TENNESSEE VALLEY AUTHORITY

In the Matter of the Application of) Docket Nos. 50-327
Tennessee Valley Authority) 50-328

Enclosed are response to the Materials Engineering Branch (MEB) questions on preservice and inservice inspection transmitted by S. A. Varga's letter to N. B. Hughes dated December 8, 1978.

5.29 Specific Areas Identified in the Review which may Require Relief

FIGURE Q5.9-1
 A COMPARISON OF THE RESPONSE FROM SIDE DRILLED HOLES WITH THAT FROM 5% NOTCHE IN VARIOUS PIPE SIZES.

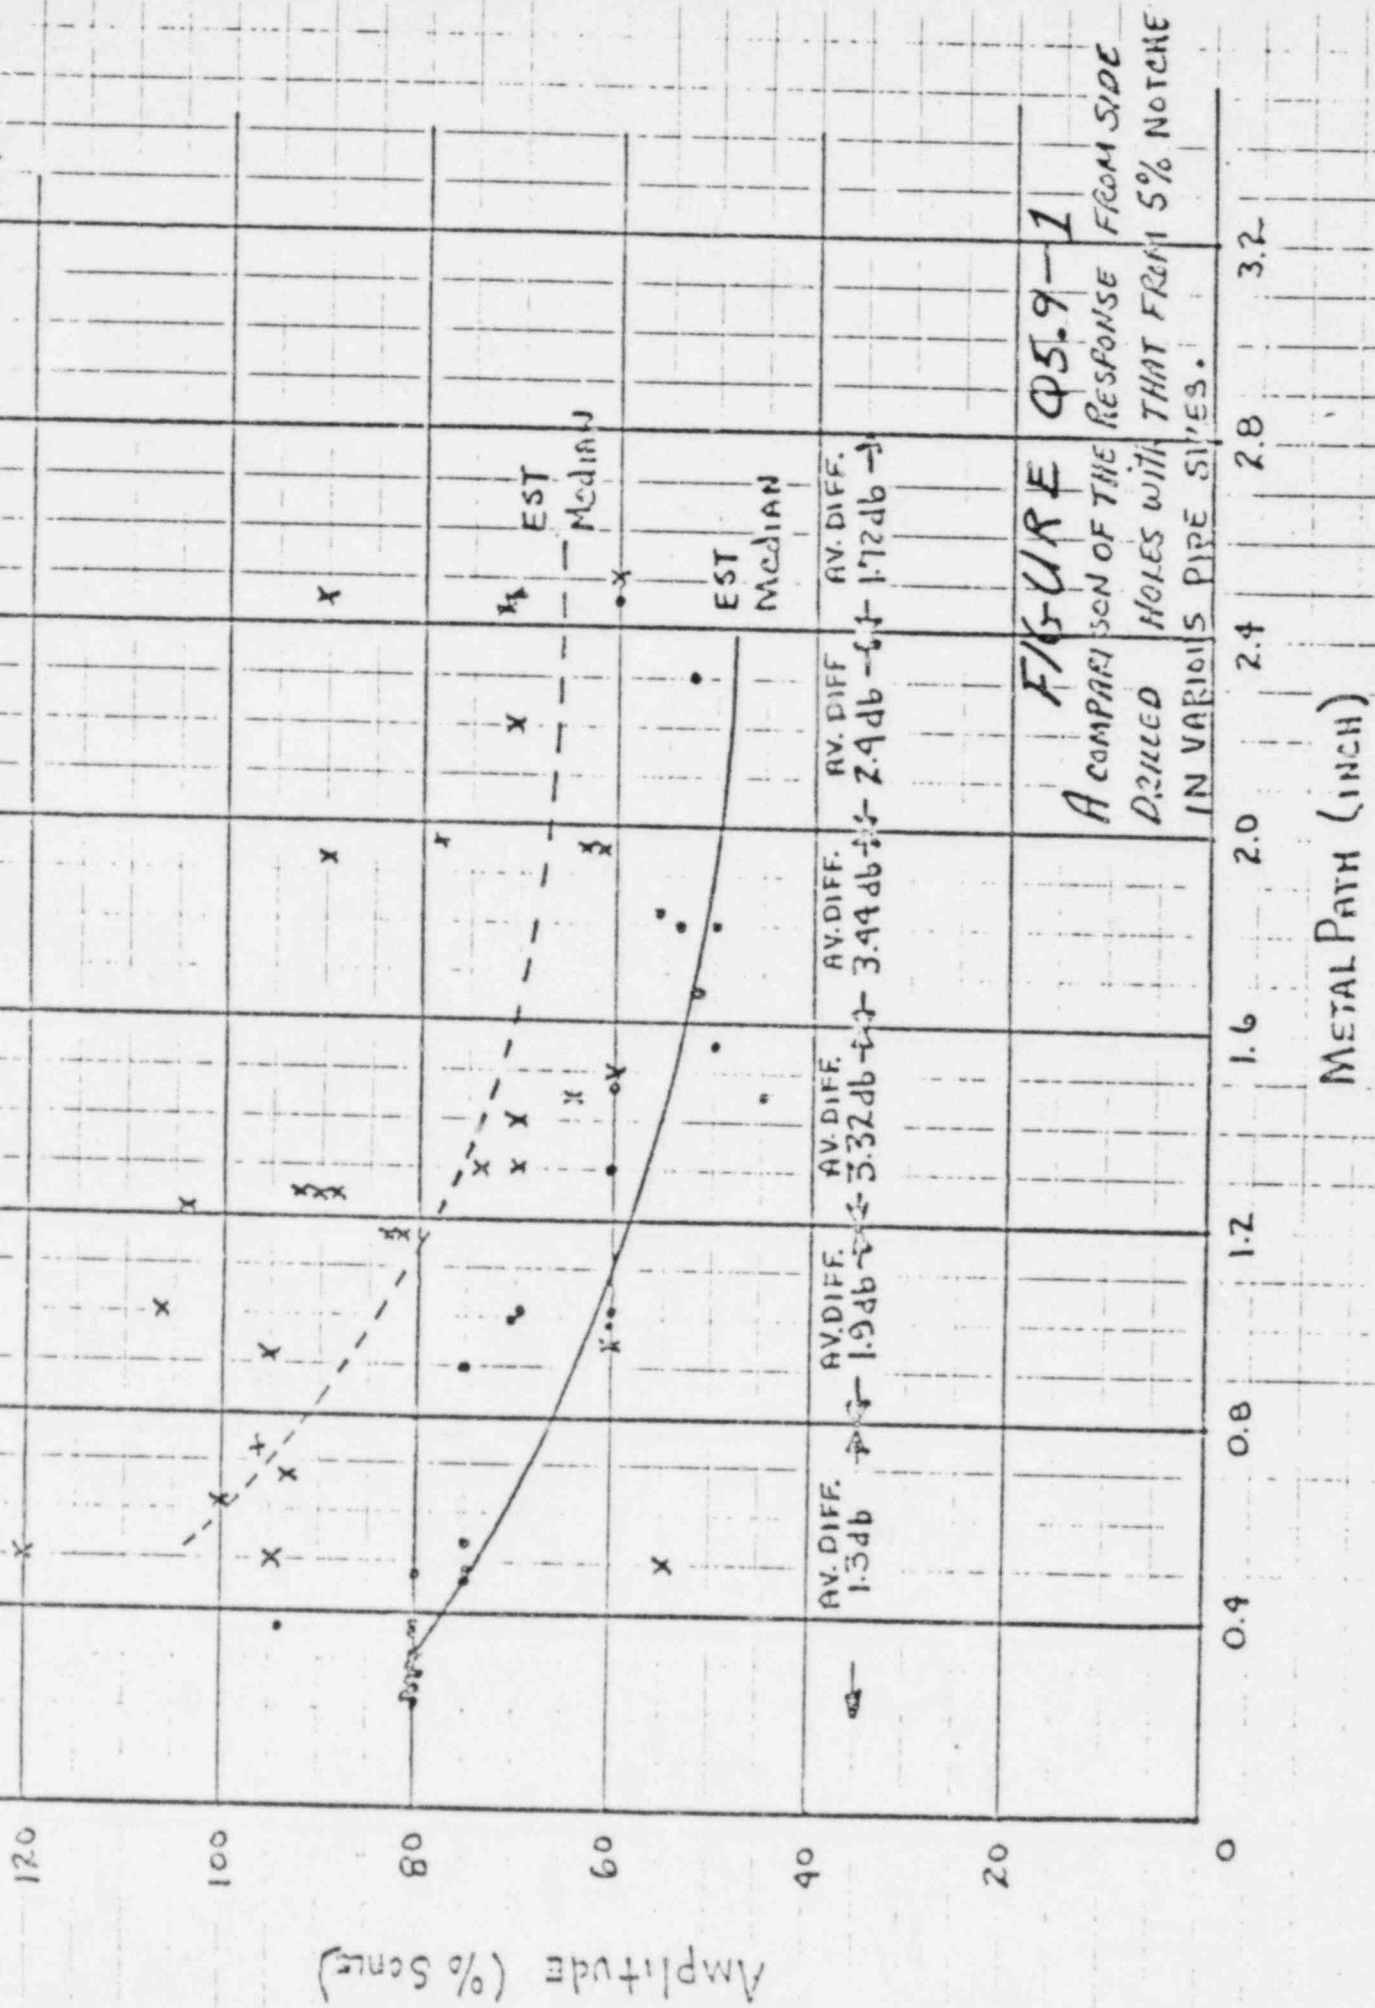
Calibration standards will not include the calibration reflector required by paragraph T-533.2(a) of Article 5 of ASME Section V.

Paragraph T-533.2(a) of Article 5 of ASME Section V requires that the basic calibration block include a basic calibration hole drilled parallel to the contact surface. However, paragraph T-533.2(b) permits the use of other calibration reflectors provided equivalent responses to that from the basic calibration hole are demonstrated. In 1973 TVA and Nuclear Services Corporation performed an evaluation of notches versus side-drilled holes in basic calibration blocks. A 5 percent notch calibration reference reflector was used to determine the primary ultrasonic reference level on pipe having a wall thickness less than 1 inch. It is demonstrated in figure Q5.9-1 that calibration with the 5 percent notch is on the average 3.5 dB more sensitive than calibration using a 3/32-inch side-drilled hole.

TVA at its discretion may use 5 percent notches in place of side-drilled holes as permitted by paragraph T-533.2(b) of Article 5 of ASME Section V.

Figure Q5.9-2

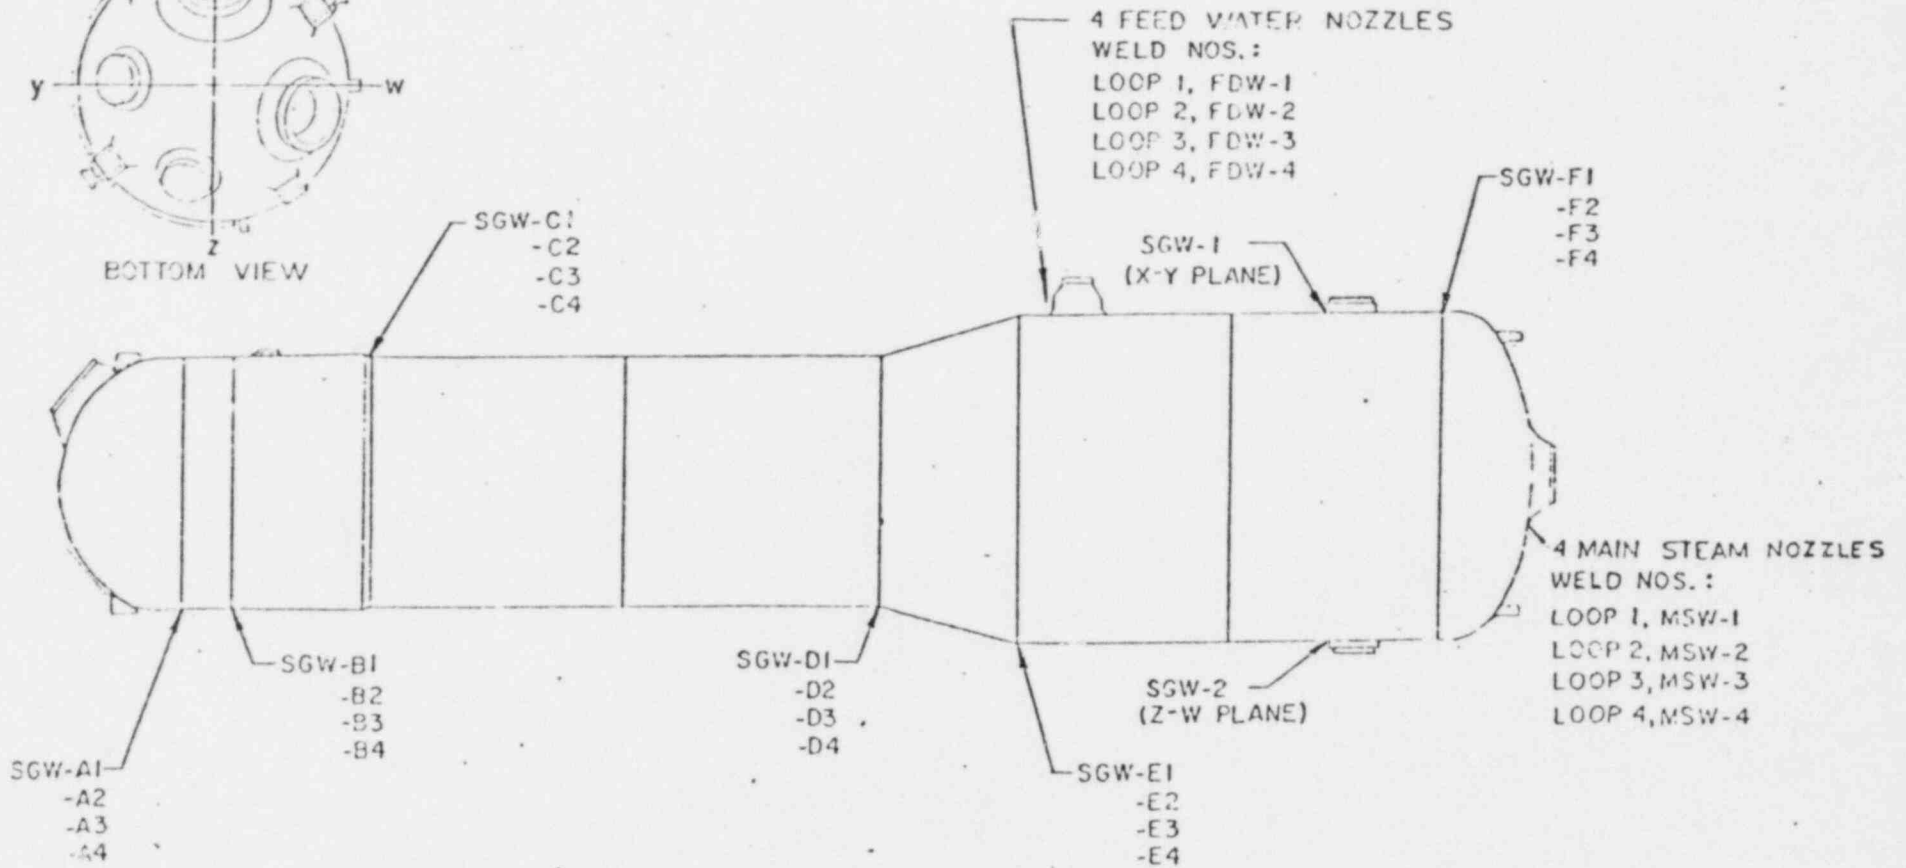
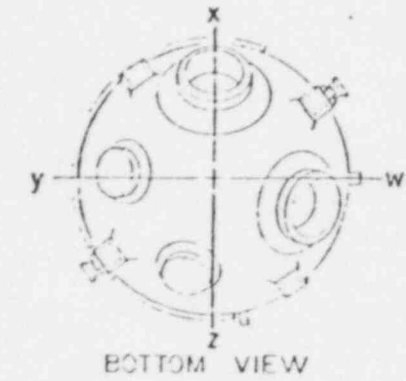
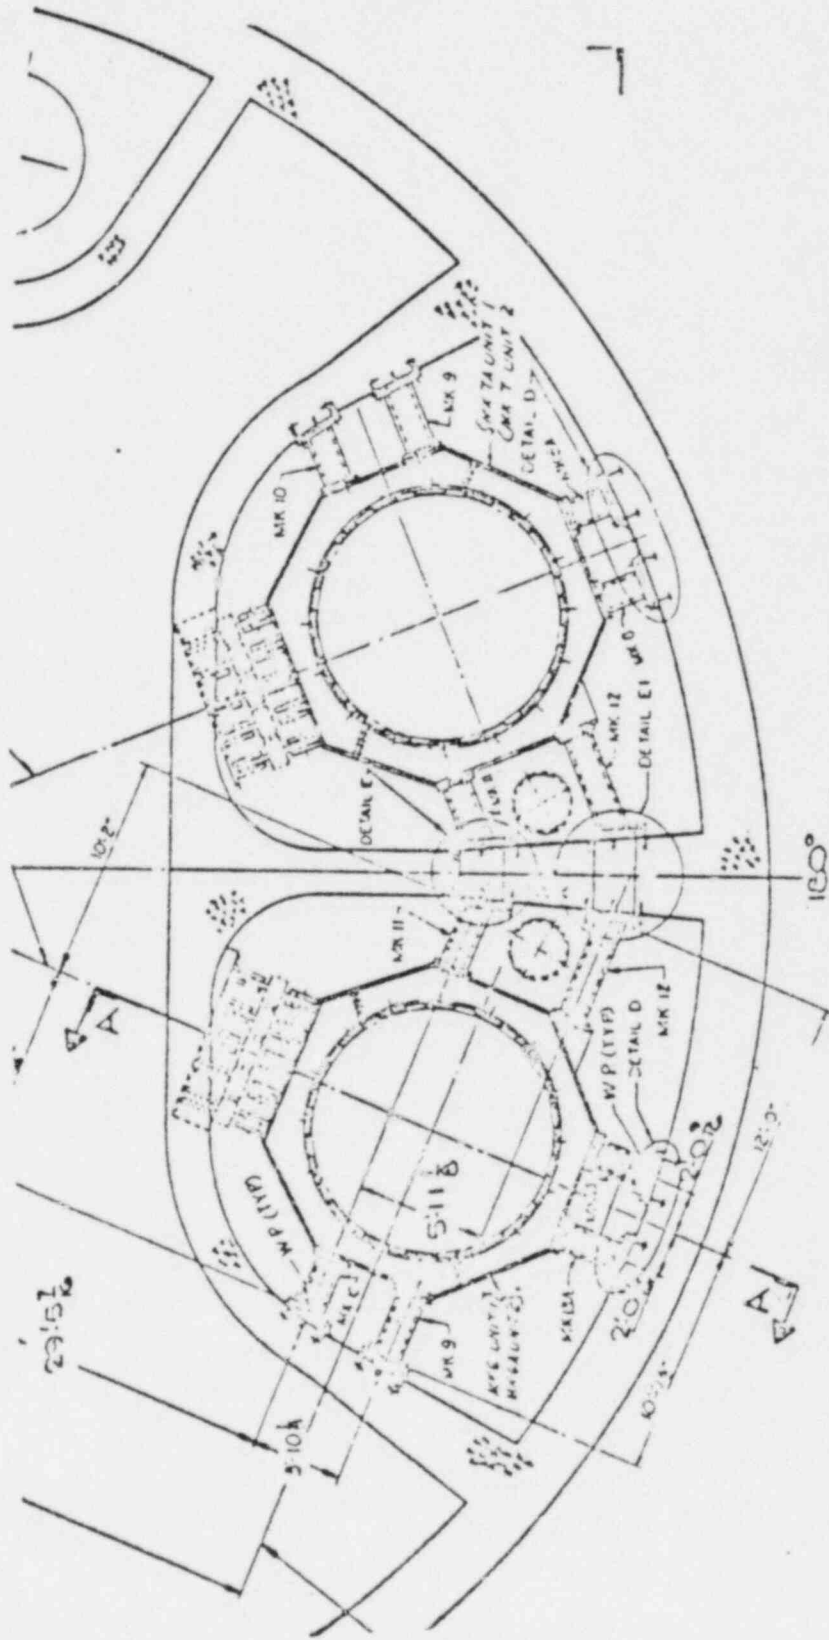
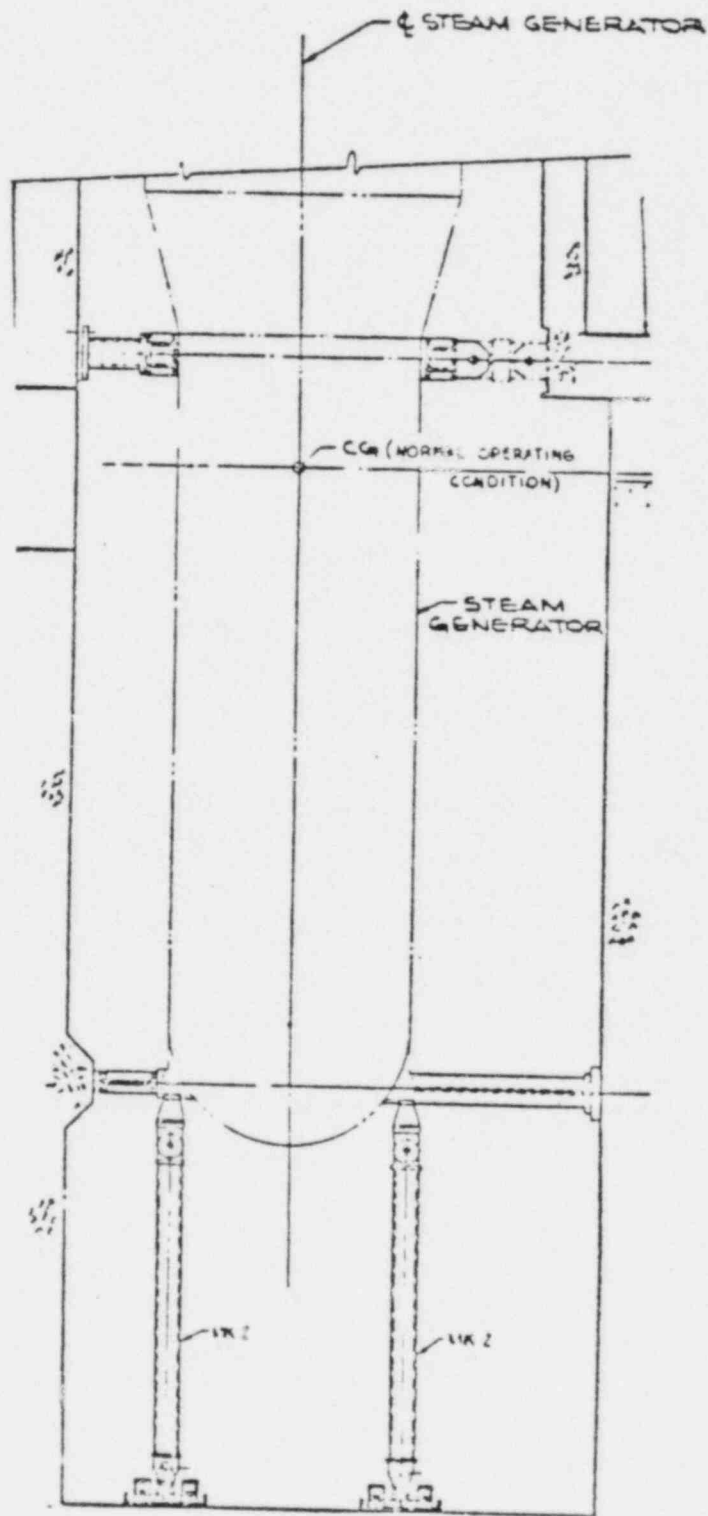
- I. Components
Steam generators (four per unit).
- II. Exception Taken
Volumetric examination of circumferential shell welds (examination category C-A) will not be completed for one weld.
- III. Justification
One circumferential shell weld on each generator is inaccessible due to the upper steam generator support brackets (weld nos. SGW-D1, SGW-D2, SGW-D3, and SGW-D4). See figure Q5.9-2 for weld location. Also, figures Q5.9-3 and Q5.9-4 show arrangements of the support brackets. One weld on one generator will be examined on a "best effort" basis for the baseline inspection and during the four inservice inspection intervals in accordance with IWC-2411.
- IV. Testing in Lieu of Section XI Requirements
None.

Figure Q5.9-5

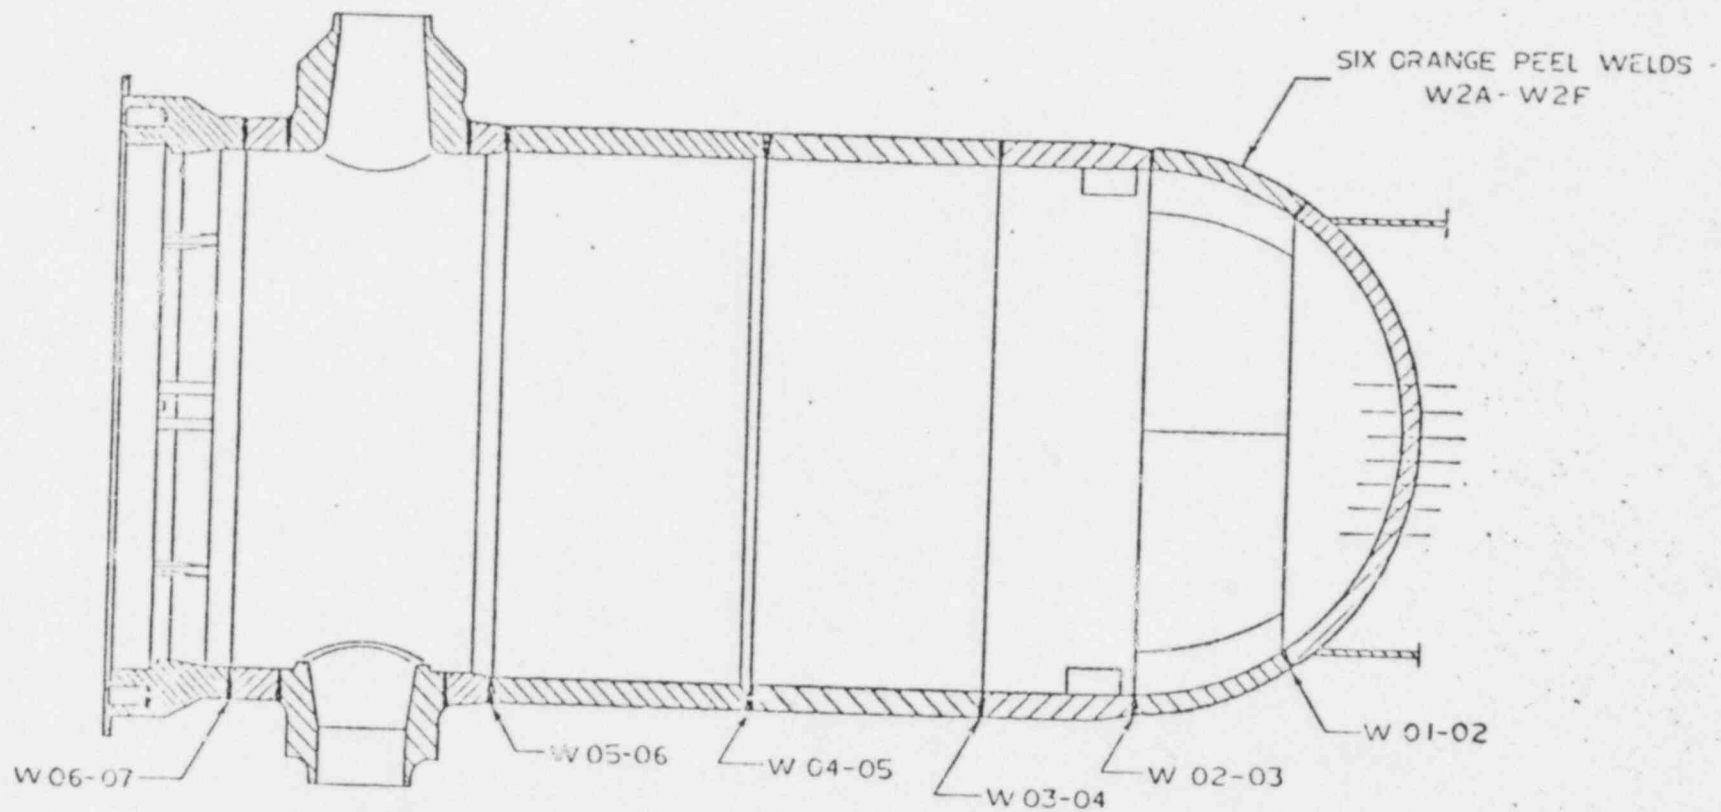
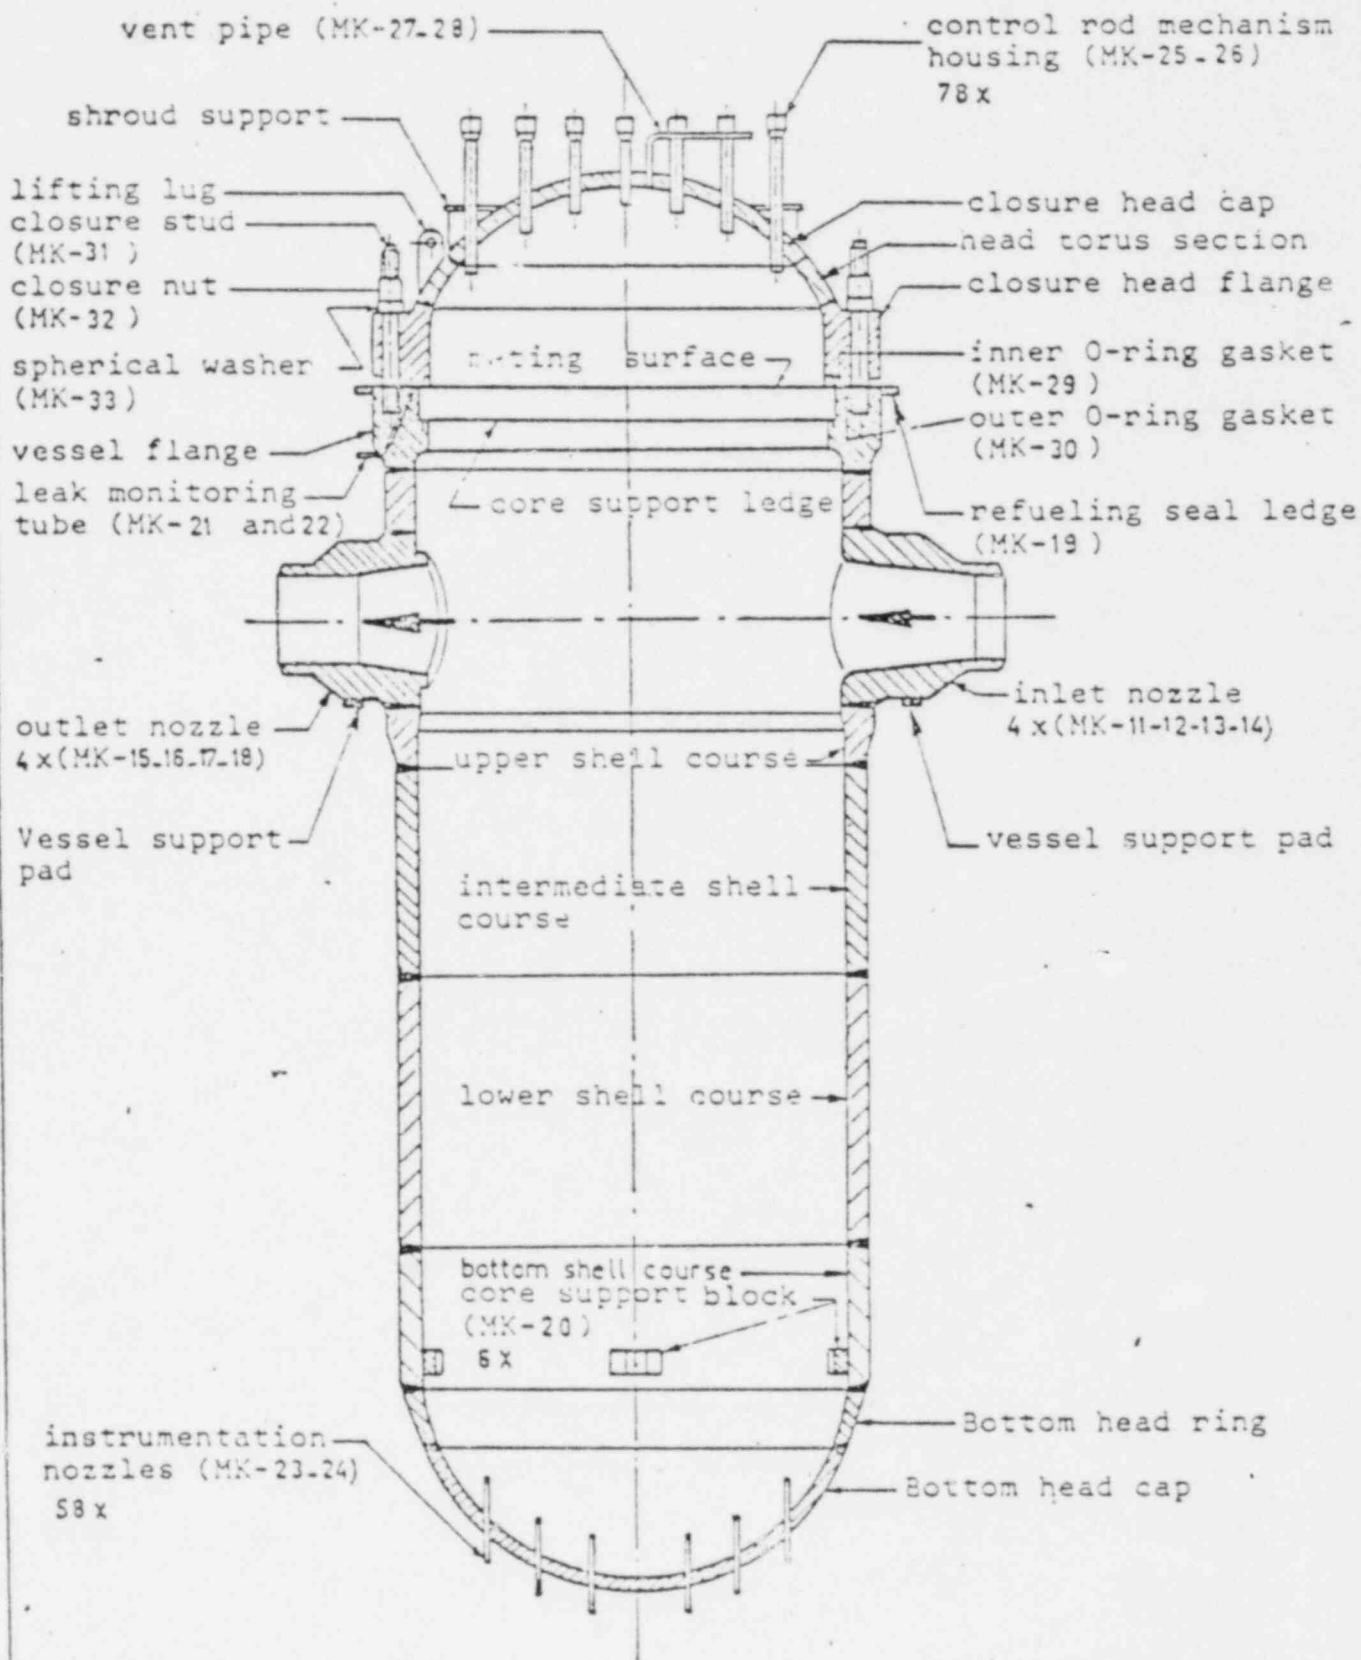
One-hundred percent preservice baseline volumetric examination of lower head dollar weld (examination category B-B) will not be made under conditions and with equipment and techniques equivalent to those expected to be employed during inservice inspection.

TVA will employ automated remote inspection devices to examine most of the reactor vessel welds. These examinations will be conducted from the vessel inside diameter. However, the lower head weld on each reactor pressure vessel is partially inaccessible for examination from the vessel inside diameter due to instrumentation tubes which penetrate the lower head (weld no. W01-02--see figures Q5.9-5 and Q5.9-6). Portions of the weld can be examined from one side (as permitted by 1-5121 of Section XI) and will include 100 percent of the examination volume in accordance with IWB-3511.1 of Section XI. These portions of the weld will be reexamined during the inservice intervals in accordance with examination category B-B of Table IWB-2500.

A 100 percent baseline examination of the weld will be conducted from the vessel outside diameter. This will be accomplished by performance of a manual ultrasonic examination. A remote ultrasonic examination will be conducted from the vessel inside diameter on all accessible areas of the weld.
